**ECE**/TRANS/WP.29/GRSG/2020/8/Rev.1

**UN Regulation No. 55 (Mechanical couplings)**

### **Proposal for Supplement 1 to the 02 series of amendments to UN Regulation No. 55 (Mechanical couplings)**

**Submitted by the expert from Finland\***

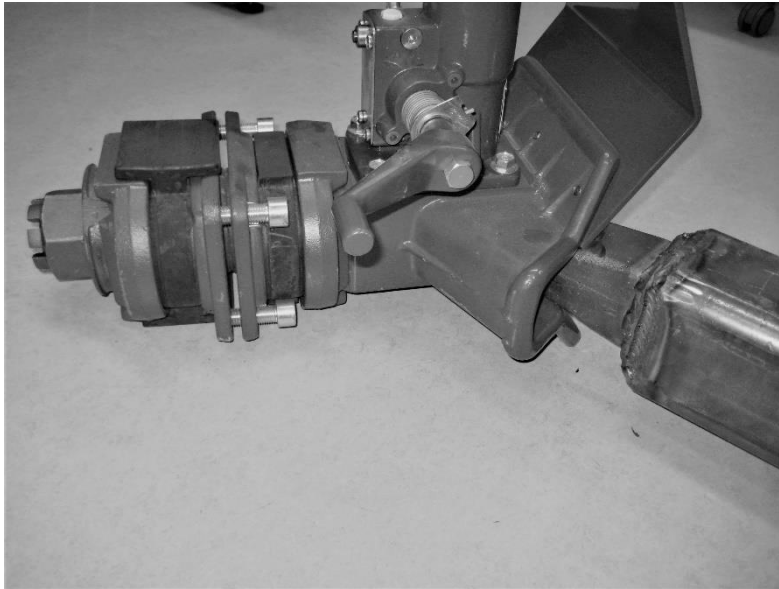
*Annex 5, paragraph 4.1., amend to read:*

- "4.1. General requirements for drawbar eyes of Class D50:
- All drawbar eyes of Class D50 shall be able to satisfy the test stated in Annex 6, paragraph 3.4.
- Class D50 drawbar eyes are intended for use with C50 drawbar couplings. Drawbar eyes shall not be able to rotate axially (because the respective couplings can rotate).
- If Class D50 drawbar eyes are fitted with sleeves, they shall comply with the dimensions shown in Figure 9 (not permitted for Class D50-C) or Figure 10. The sleeves shall not be welded into the drawbar eyes. Class D50 drawbar eyes shall have the dimensions given in paragraph 4.2. The form of shank for drawbar eyes of Class D50-X ~~is not specified, but~~ **shall be limited by the form drawn in Figure 11 and** for a distance of 210 mm from the centre of the eye the height "h" and the width "b" shall be within the limits given in Table 6."

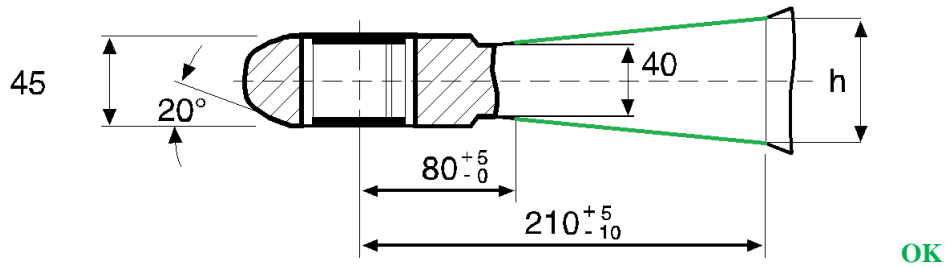
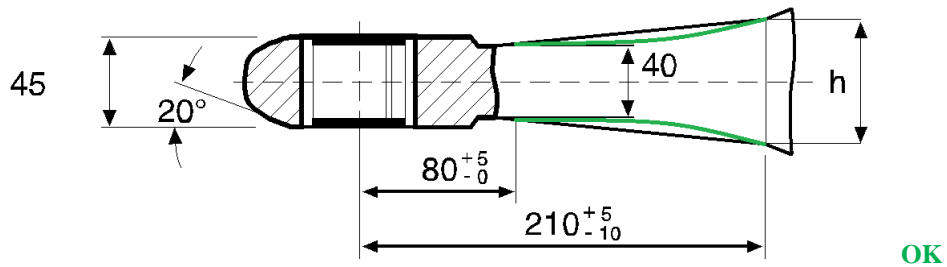
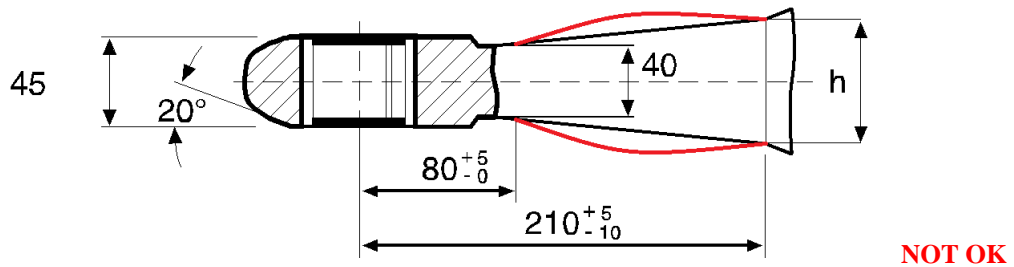
High capacity vehicle combinations made possible in Finland require high D-value coupling devices. This means the dimensions of the coupling devices are often very near to the limits of the current regulations. In Finland incompatible type-approved drawbar eyes and drawbar couplings has been found in the market surveillance. The main issue is the vertical thickness of the shank of the drawbar eye. Maximum dimensioned D50-X shank cannot fully articulate inside of C50 drawbar couplings as shown in the photographs below.

Clarified dimensioning of the D50-X shank would ensure the compatibility with the C50 couplings.
